HARBOR GRACE ST., LONG ISLAND 100-A-1-2

Subject: Building permit for reconstruction of
front and side piazzas on cottage at the corner
of Fern Avenue and Harbor DeGrace Street, Long
Island, owned by J. F. Dorsey and Lena Bickford

Subject: Application for building permit to make alterations in cottage owned by Mrs. Lena Bickford on Woodman Street, Long Island, near Harbor de Grace Street and make thereof a year round dwelling

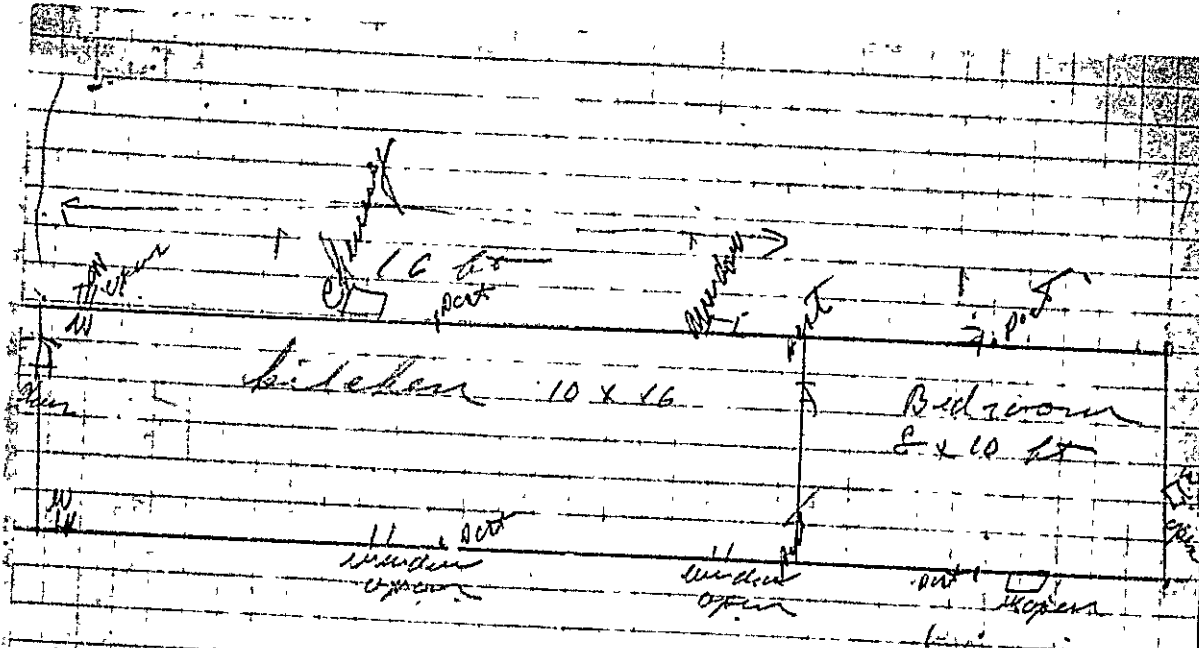
1. The front and side porch and porch should be removed
and rebuilt structurally correct.

2. No present boarding now used as inside wall covering
to remain, or be removed for new pressed board.

3. Where is ceiling level, at plate as per plan by Mr
Wood shown above plate.

4. All windows are nailed in, non-operative.

5. Chimney ok for clearance but should have a clean-
out door and should be 3'-6" higher.

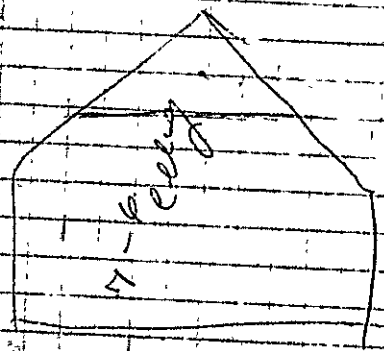
main part 10 x 18
 rafters 2 x 4 @ 20 oc
 studs 2 x 4 @ 16 oc
 chimney 2 in away from
 wood cobbled in to base
 There is to be ~~no~~ partitions
 new part 8 x 10
 rafters 2 x 4 @ 12 oc
 studs 2 x 4 @ 16 oc

Coll. of ceiling beams
 dropping ceiling
 to be fastened to

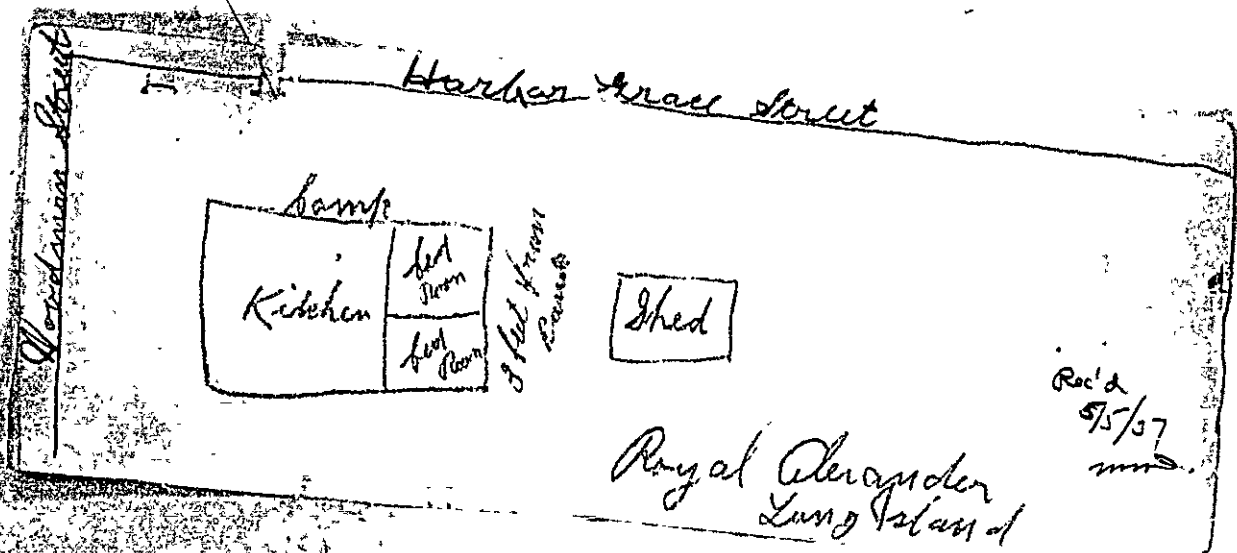
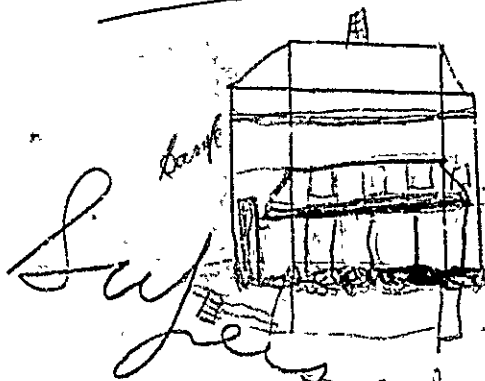
I am unable to issue the permit applied for to cover moving an existing shed at Harbor Grace, corner of Goodman St., Long Island, and attach it to an existing camp or cottage on the same property, because the framing of the shed is very light and does not satisfy Building Code requirements for the framing of any part of a habitation.

You have told our inspector that you might decide to locate the shed some space from the camp, and, I presume, from the new location sketch which we received from you on May 5th, that you have decided to set the shed three feet from the camp.

Although you are not forbidden by law to locate the shed three feet from the camp, since you have plenty of land, I respectfully suggest that you set the shed at least ten feet from the camp, unless there is a definitely good reason for placing closer, thus improving the appearance and probably the value of the property.
